AGNICO EAGLE

2AM-WTP1826

Information Request Responses

Whale Tail Pit – Expansion Project

Figure ECCC-IR3-1: Conceptual Model of Deep Groundwater Flow Regime during Mining - Cross-Section View

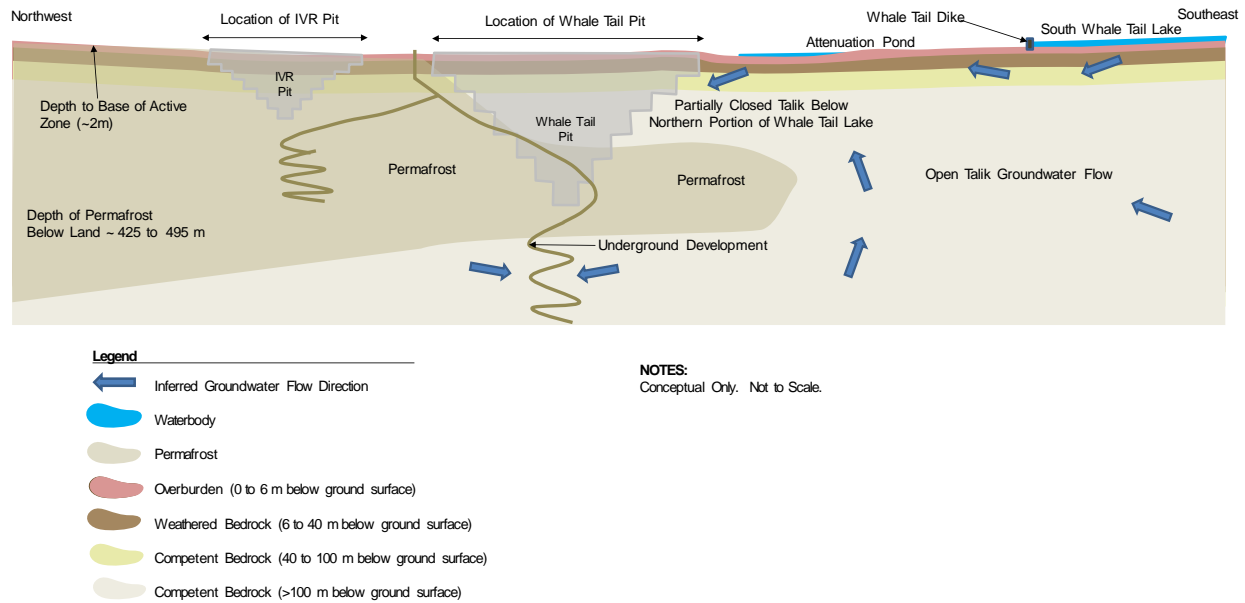
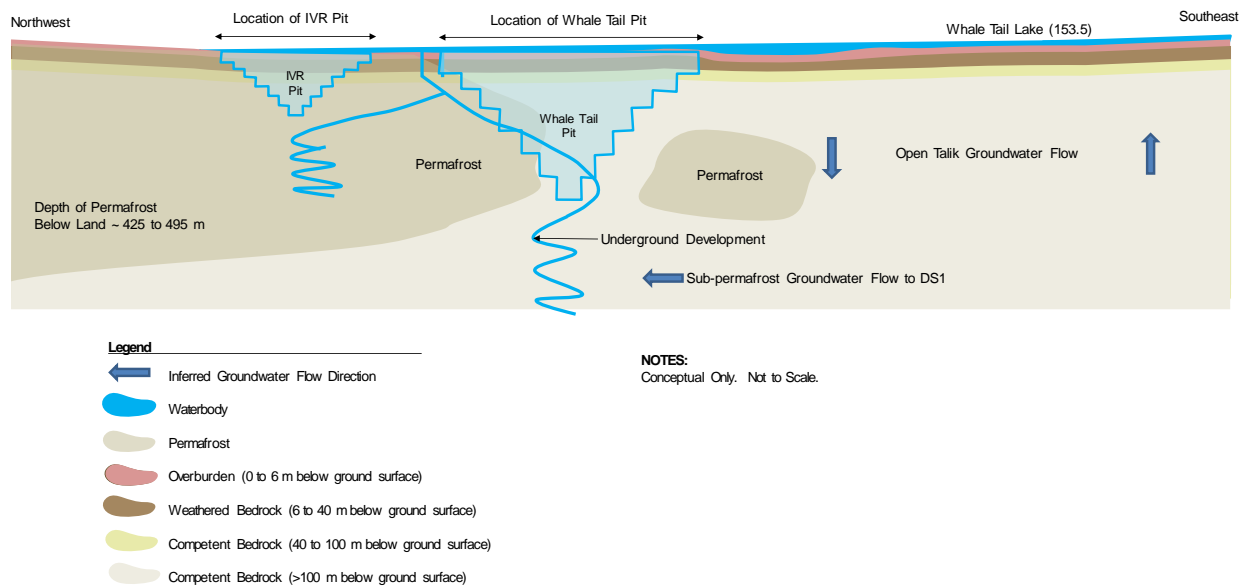
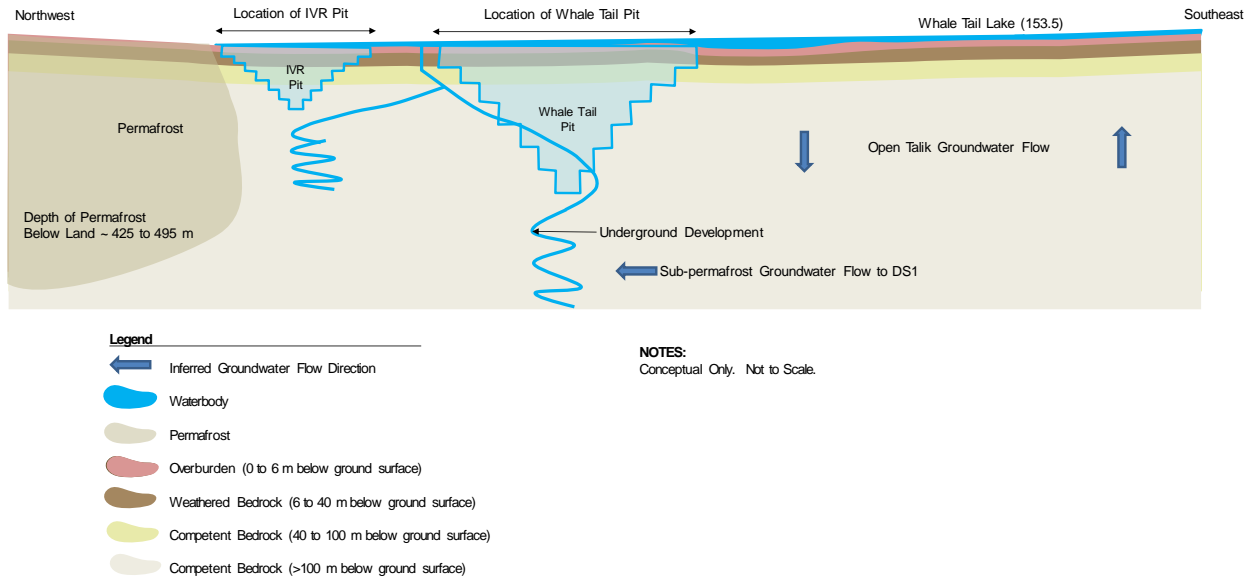
ECCC requests that the Proponent clarify the large discrepancy between the length of time it takes for permafrost to melt completely underneath Whale Tail and IVR Pit Lakes.

- Figure ECCC-IR3-1. At the end of mining.
- Figure ECCC-IR3-2. At the end of closure.
- Figure ECCC-IR3-3. 1000 years into post-closure.

IVR Pit is located within regional permafrost, and because of the increased thickness of permafrost surrounding the pit, it takes longer to fully degrade the underlying permafrost. Whale Tail Pit is in an area of partially closed talik, and because of the smaller volume of underlying permafrost, the permafrost degrades faster.

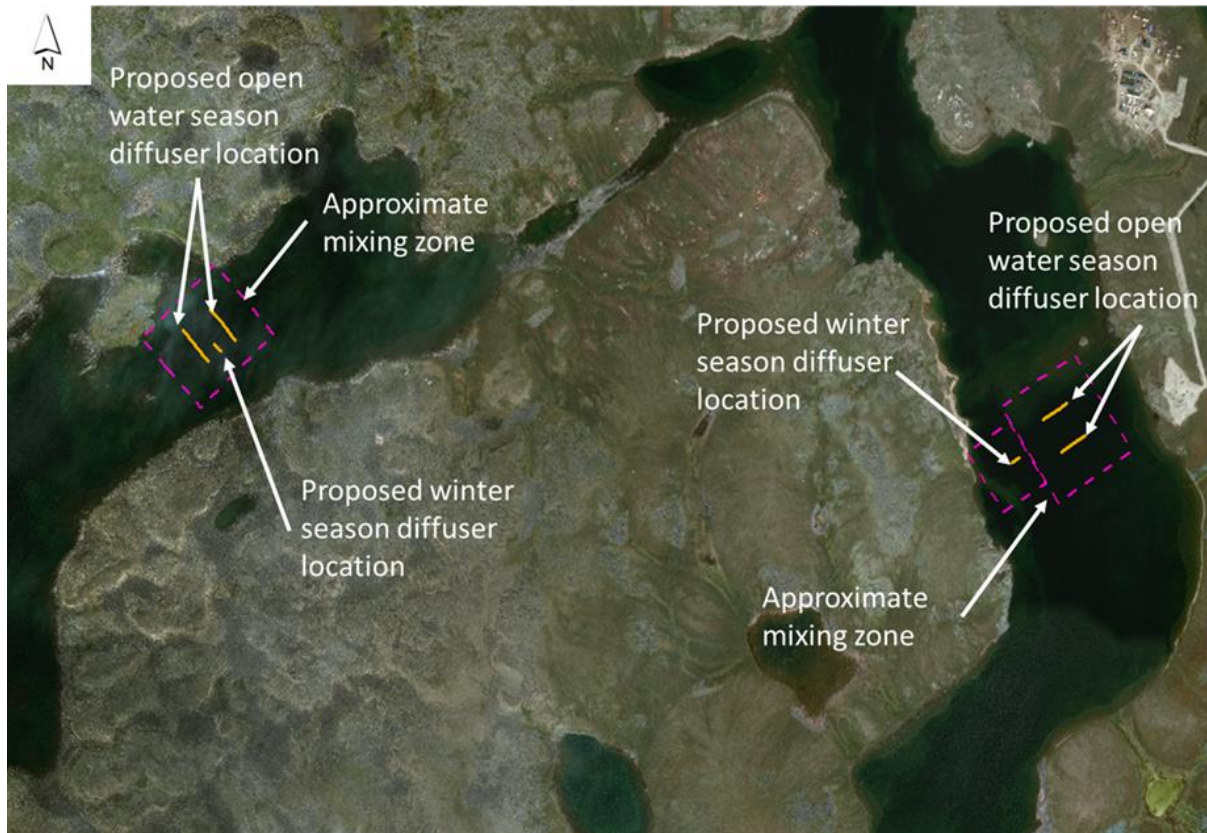
ECCC requests that the Proponent provide:

- *A map indicating the location and extent of the mixing zone for each diffuser, including all planned and potential open season and winter diffusers for the Project.*
- *A description to explain the map and outline the timing of discharge to each diffuser location.*

The figure below shows the location and extent of the proposed regulatory mixing zone for each diffuser, including all planned and potential open water season and winter diffusers for the Project. In Mammoth Lake, the open water season diffusers will consist of two diffuser lines, each with ten ports that are spaced 12.6 m apart. In Whale Tail South, the open water season diffusers will consist of two diffuser lines, each with seven ports that are spaced 14 m apart. The winter diffusers for both receiving lakes will consist of only one line in each lake, with three ports that are spaced 14 m apart.

Figure 1. Predicted total concentrations in effluent discharge. TSS is assumed to be 7.5 mg/L.

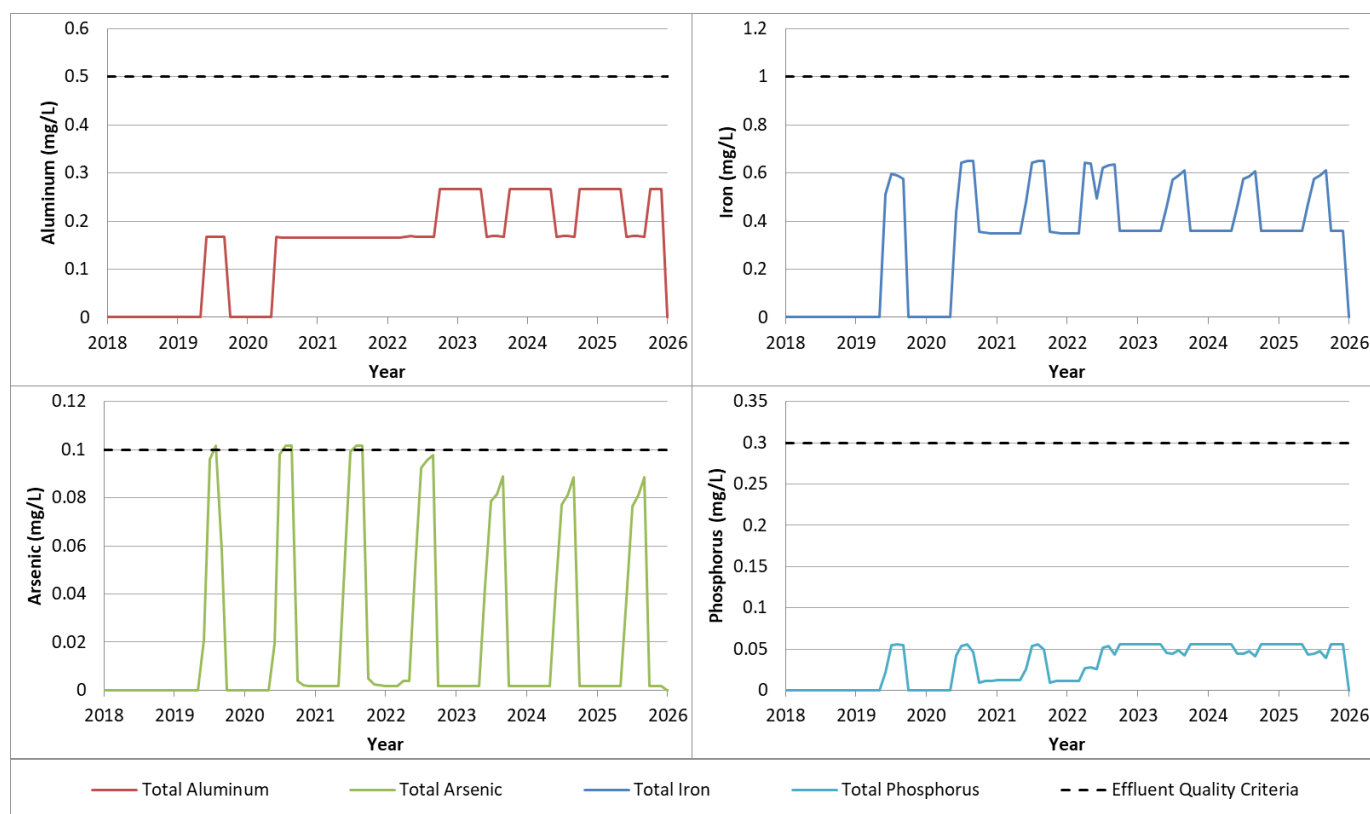
ECCC requests that the Proponent provide:

With the assumption of 7.5 mg/L TSS in the effluent during operations, aluminum, iron, and phosphorus remain below their respective Effluent Quality Criteria (EQC). Dissolved arsenic is assumed to be treated to 0.1 mg/L. In the model prediction for total arsenic, 0.0018 mg/L of particulate is added, which causes the total arsenic concentrations to occasionally exceed the effluent quality criteria of 0.1 mg/L. However, the treatment plant is designed to treat total arsenic to 0.1 mg/L and the small exceedances are not expected during operations..

Figure KivIA-WL-IR4-1. Comparison of weather records for 2019 with those used to develop the original 2019 seepage model.

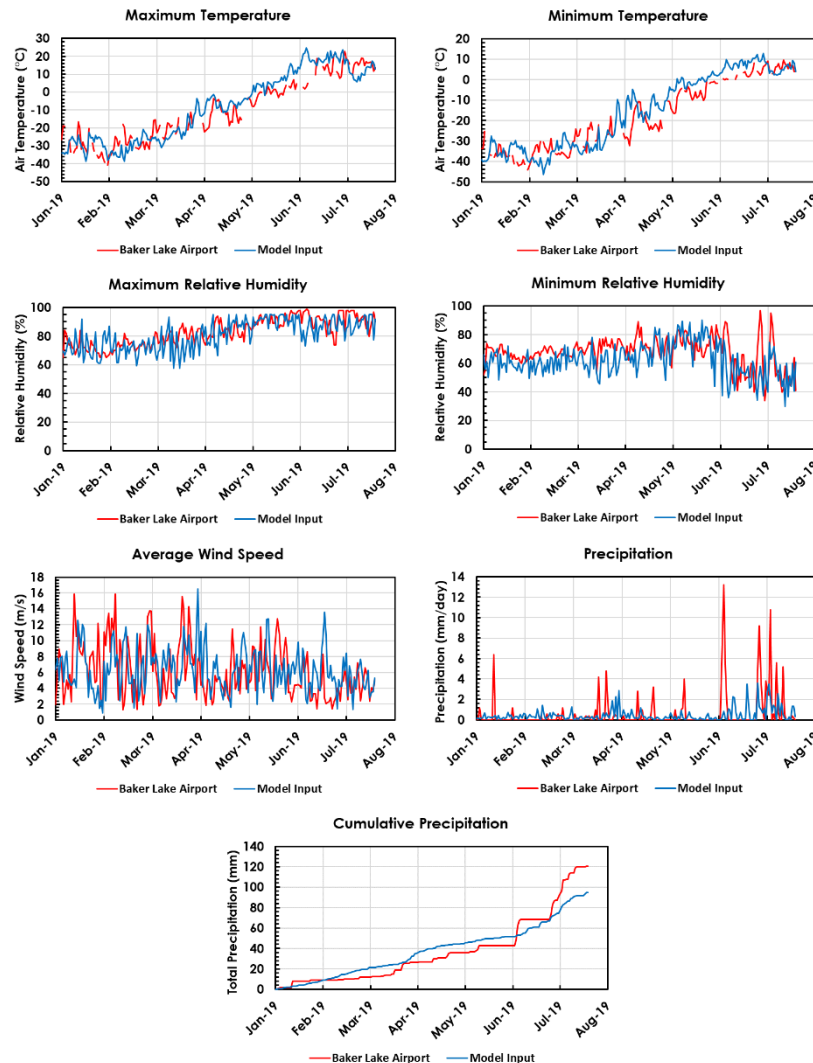
Please provide a comparison of weather records for 2019 with those used to develop the original 2019 seepage model.

- The model input slightly overestimates temperatures in the late spring to early summer period.
- Relative humidity shows less variation in observed data than was estimated for model input. The overall trend in both maximum and minimum relative humidity matches observed data.
- Predicted wind speed is within the observed range.
- Large precipitation events are underestimated by the model input.

The model input is dominated by many small events, while observed data is dominated by a few large events. Total cumulative precipitation is a better match, but is still underestimated for the year so far, with observed cumulative precipitation totaling approximately 120 mm, while the model inputs estimated approximately 95 mm. Based on the Meadowbank weather station data, Meadowbank typically receives less precipitation than Baker Lake, so the model input is likely a good match to Whale Tail, as shown in the figure below.
